## **Product Change Notice (PCN)**

PCN Number: PCN-0450735R-01

Product(s) Affected: PJ-014DH-SMT-TR

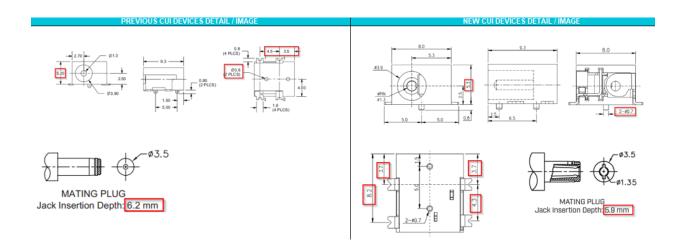
Description of Change: Mechanical, electrical, and material changes as shown below:

MATERIAL	PLATING
cernter pin	copper	nickel
erminal 1	brass	silver
terminal 2	copper alloy	silver
terminal 3	brass	silver
plastic	PA6T or equivalent

DESCRIPTION	MATERIAL	PLATING/COLOR	
center pin	brass	silver	
terminal 1	brass t=0.50	silver	
terminal 2	bronze t=0.25	silver	
terminal 3	brass t=0.50	silver	
housing	PA10T (UL94V-0)	black
